## TT00003 Revised Valve Guide & Seal On 2006-2010 GM 6.6L Diesel VIN 2, 6 & D Engines

S. B. International, Inc., offers the following information on a revised valve guide and valve seal that began in 2010 with production LGH and LML engines. These revised components may be used as service parts any time these heads are serviced.

Figure 2.

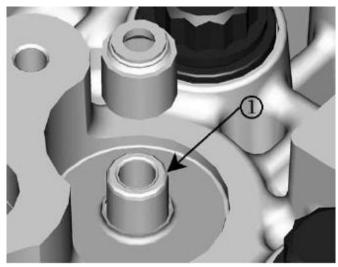
**Figure 2**. The second design valve guide does not have this groove, as the valve stem oil seal is a pressed fit to the guide (1). This design used GM P/N 12624396. When servicing an engine with the second design valve guides, be sure to use EN-49761 to install the valve stem oil seal to the correct height. The EN-49761 is tapped down until it bottoms on the lower valve spring seat.
